SUBJECT: Trinity PAD (H) Clarification and Minor Amendment Request

Subject: **Trinity PAD(H) Clarification and Request for Minor Amendment**
Activity No: C9-16-13
400 E. University Blvd.

**Trinity Design Revisions since IID Approval Elevation Comparison
IID-17-03**

THE
TRINITY

PHASING SITE PLAN

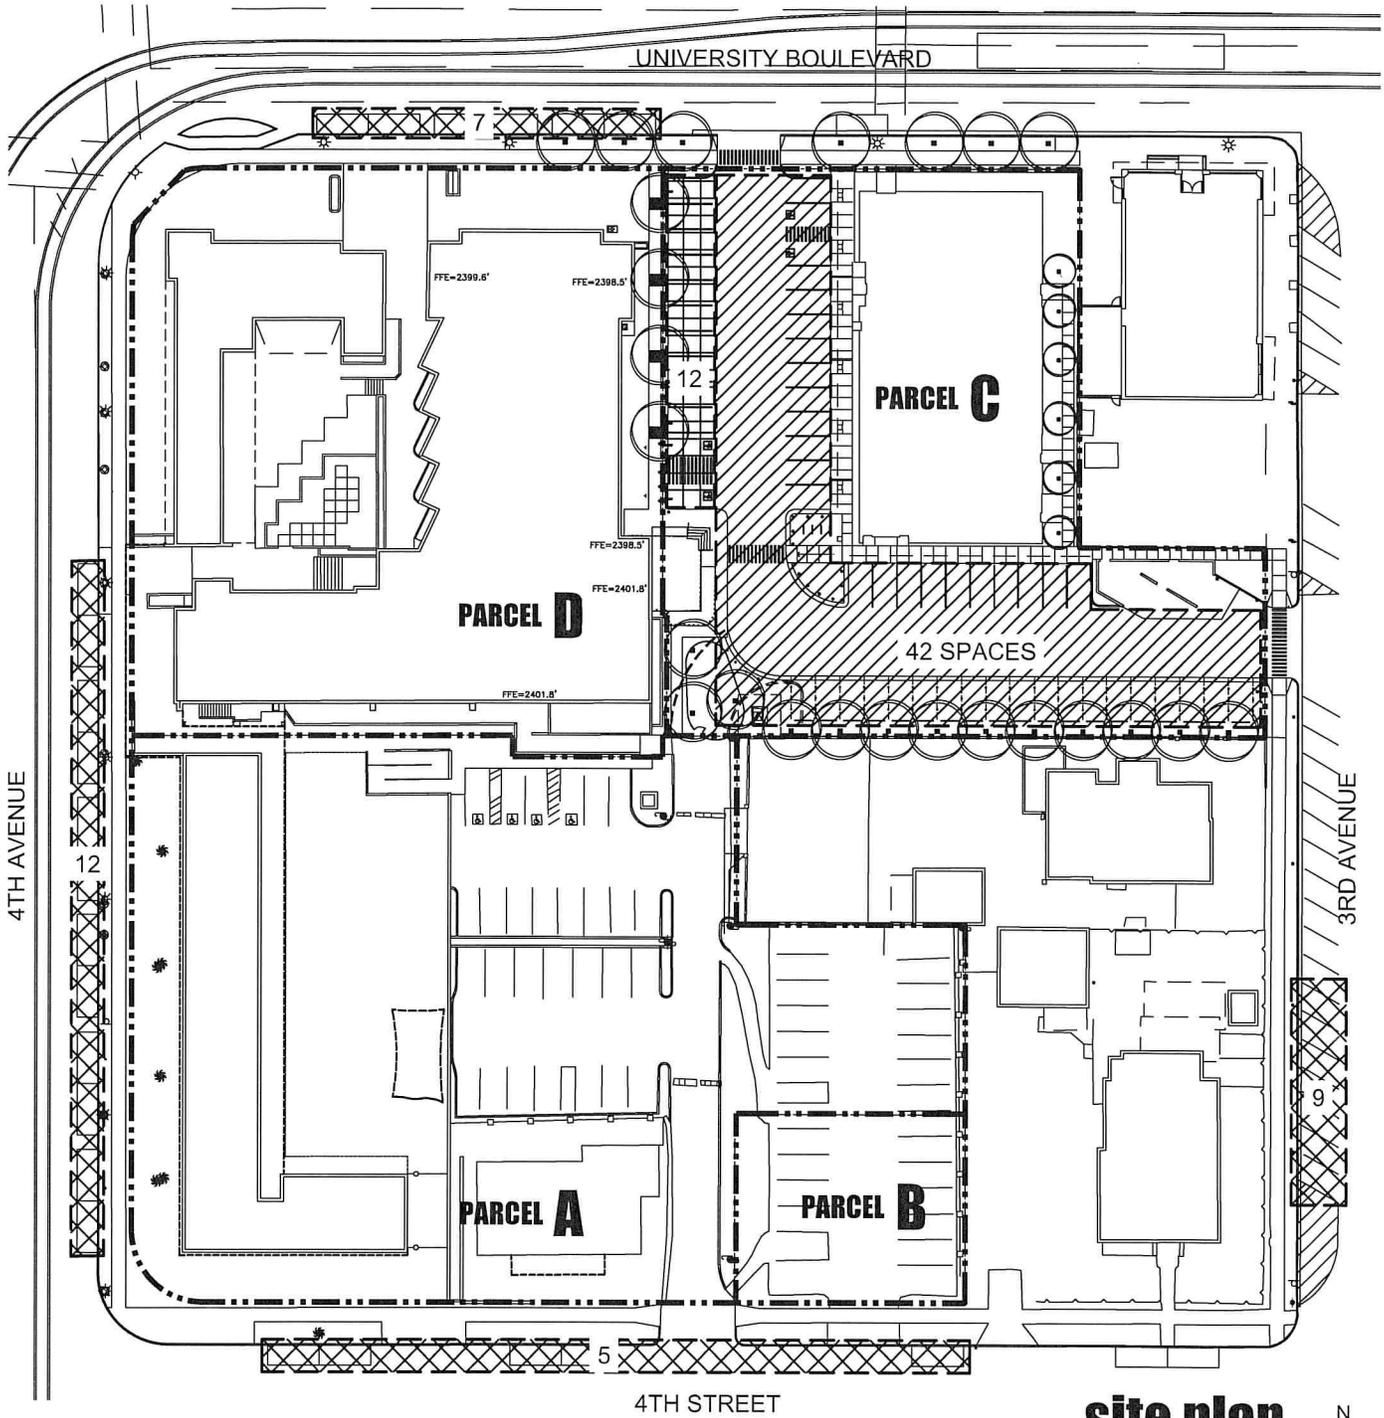
The Trinity project will be completed in two phases: the north half of the site will be developed as the first phase and will meet the PAD requirements for drainage, parking, trash, fire, pedestrian access, and landscaping. The south half of the site will be developed as the second phase, and will include: moving of the bungalow and the associated reviews, easements for the residential building over the ROW, and PIA for the proposed parking in the ROW.

Phase one will include the following:

- 25,147 SF Office building.
- Parking lot and Parking Area Access Lanes
- Pedestrian connection from University Blvd. to the new office building and adjacent Trinity Church.
- New trash enclosure to serve the new office building, Trinity Church, Time Market, adjacent residents, and future phase uses.
- Landscape elements including required screening, streetscape, and internal landscaping to provide shade for pedestrians and automobiles.

Phase two will include the following:

- Demolition of existing Children's Building and canopy (noted in PAD as Building C1 and C2, Exhibit C, Existing Development).
- Relocation of historic bungalow (noted in PAD as Building D, Exhibit C, Existing Development)
- New 62,039 SF mixed-use building including 55,459 SF multi-family residential (58 apartments) and 6,580 SF retail/food service.
- Parking areas and PAALs
- Pedestrian connections from 4th Avenue and 4th Street to the new mixed-use building
- Completion of pedestrian connections providing access through the site
- Landscape elements including required screening, streetscape, and internal landscaping to provide shade for pedestrians and automobiles.

PHASE ONE PARKING

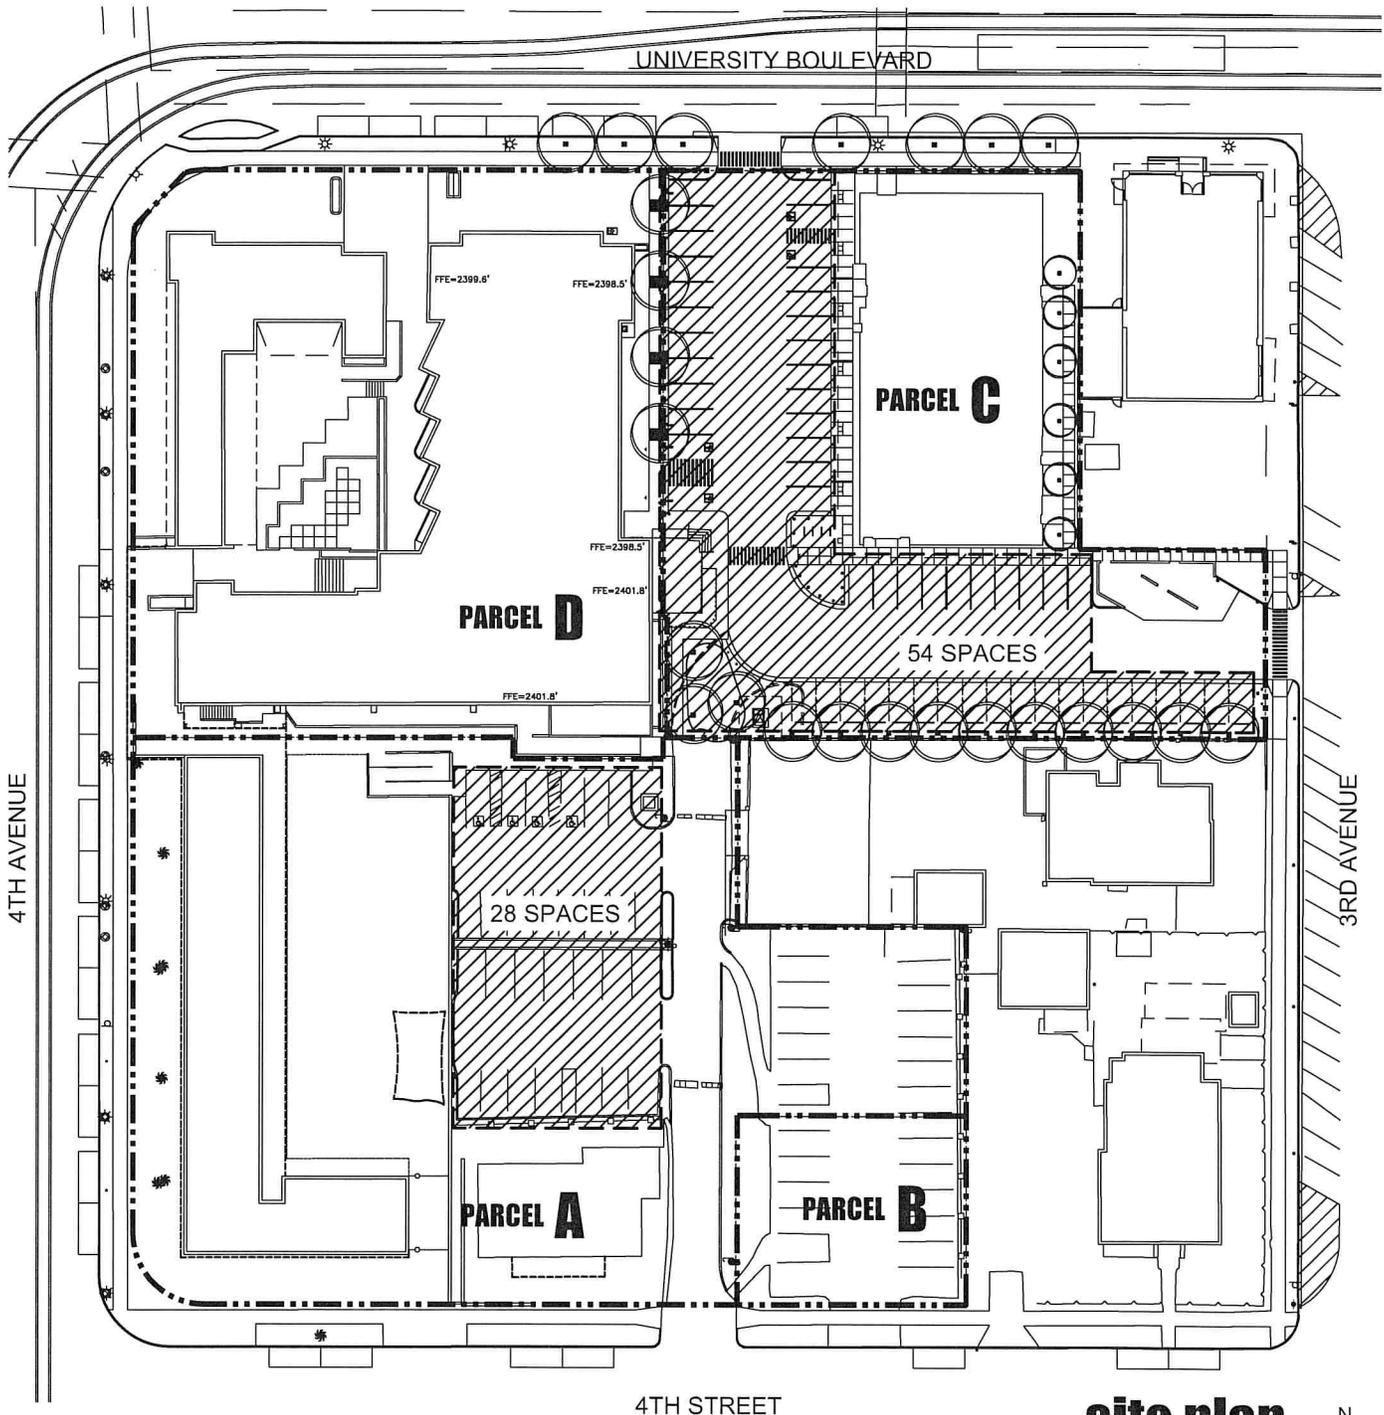
We have modified and refined the parking from what was anticipated in the approved PAD(H) document. Phase one now includes a medical clinic in place of the proposed retail/food service. The shared parking agreement with the church has also changed with 12 spaces permanently assigned to the church in phase one, 54 total on-site spaces available to the church on Sunday, and the balance of the required spaces will be available in the existing parking located on the south parcel. The Phase two development will provide additional on-street parking - increasing the total available from 49 to 55.

DESIGN CHANGES SINCE IID APPROVAL - ELEVATION COMPARISON

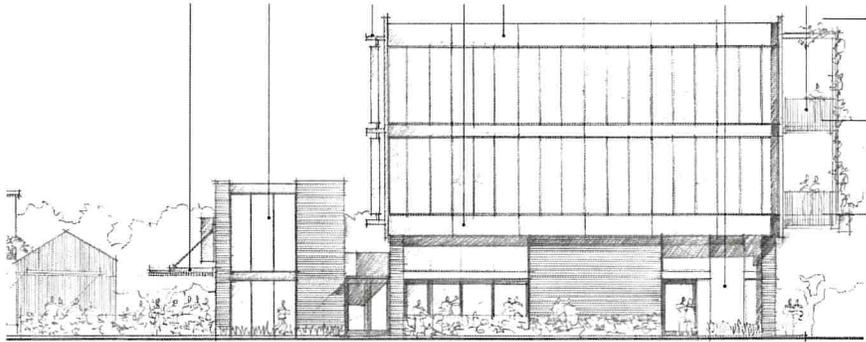
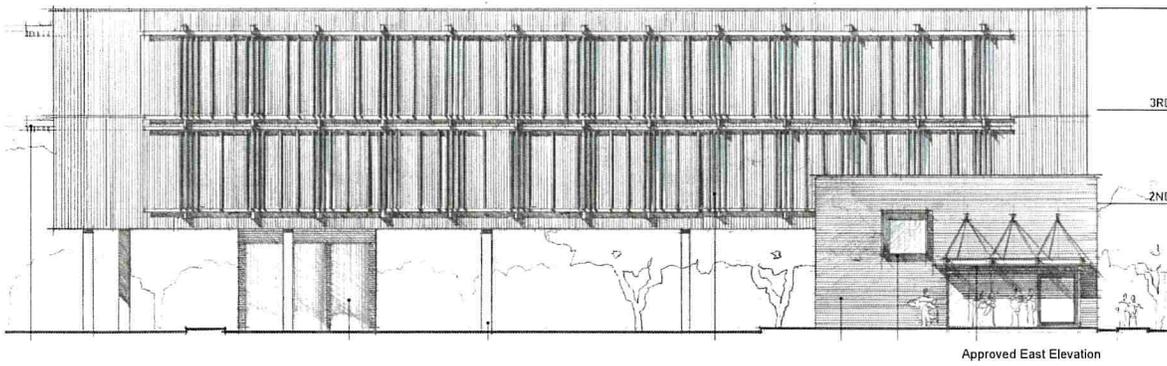
North Elevation

- Building height adjacent to Time Market reduces in height by 5' from 25' to 20'
- Structural system changes from steel to heavy timber thereby reducing glass height from 12' to 11' at all elevations due to deeper beams
- Storefront simplifies to reflect larger, one tenant on lower floor with lobby entrance to the top two floors off the east elevation
- Overhang at west creates shaded walkway

Revised South Elevation

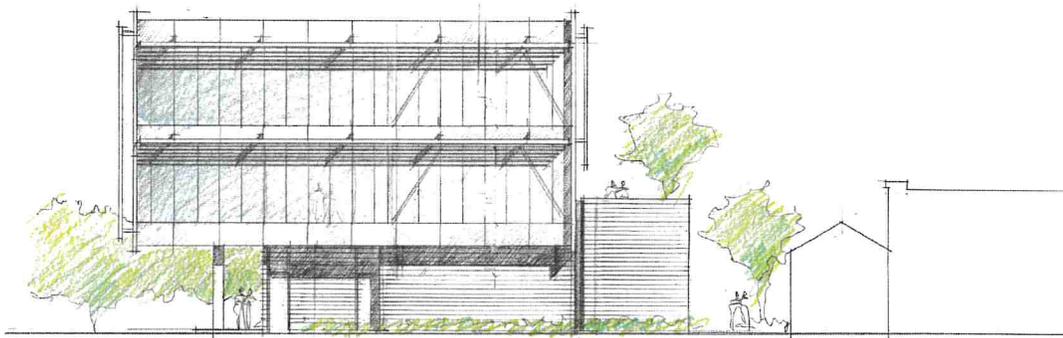
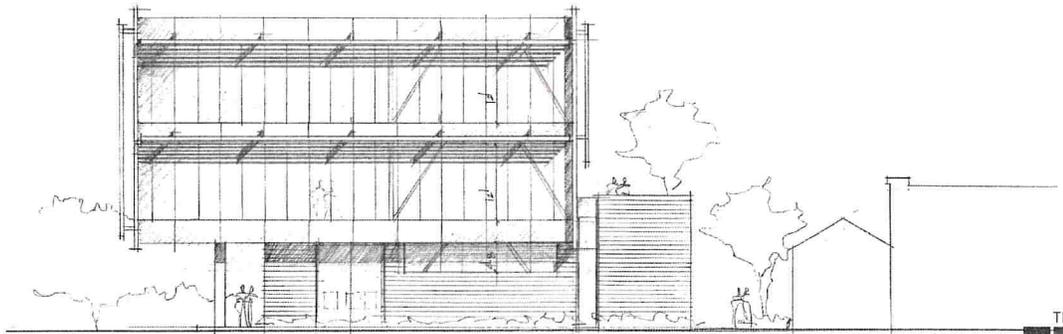
South Elevation

- Lower floor fills in with ground floor tenant space
- Overhang at west creates shaded walkway

Revised West Elevation

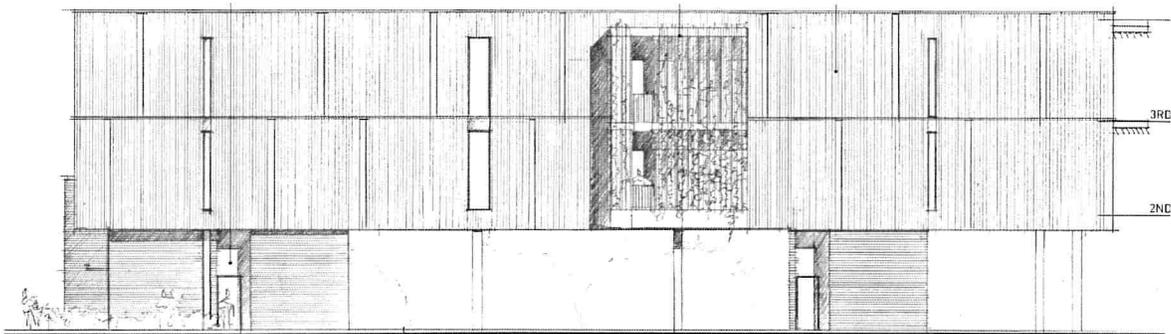
West Elevation

- Upper floors reduce in size and mass
- Lower floor fills in with ground floor tenant space
- Primary entrance to upper floors is created at west façade

REVISED SITE PLAN

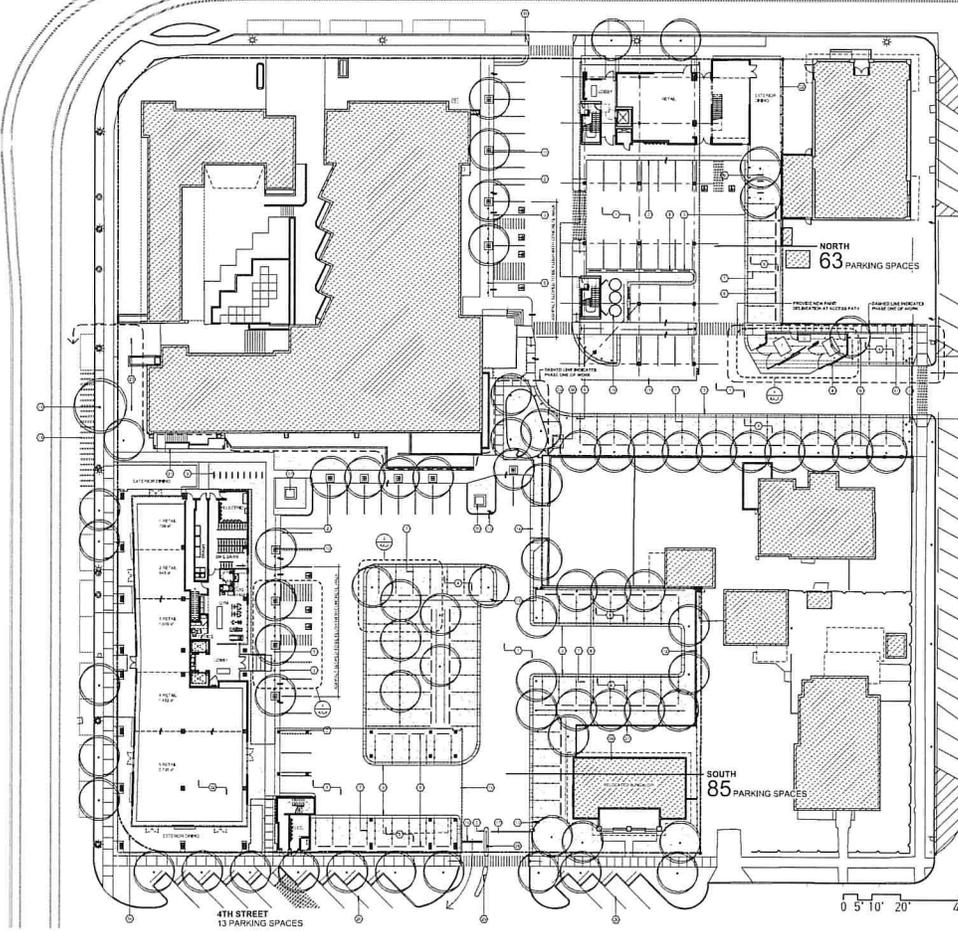
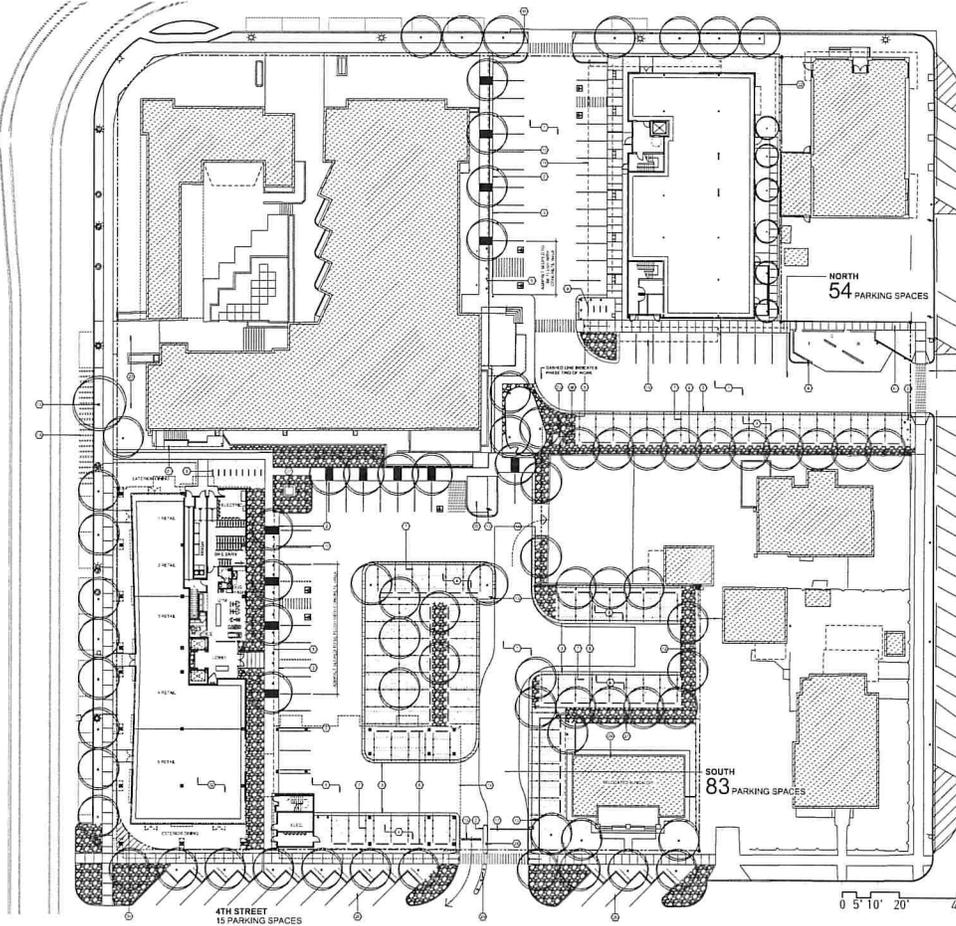
- A larger portion of the building will touch the ground plane to create more leasable space on the first floor. This larger ground floor will provide access on all four sides to create a more historical approach to how the building connects to the ground plane.

- This greater use of the ground plan also eliminates the parking under the central portion of the building of the previous scheme and reconfigures the parking around the building per the requirements set forth in the PAD (H) document.

- Square footage at upper floors reduces slightly at 2nd and 3rd floors.
- The overall square footage of the building increases from 20,924 SF to 25,147 SF.
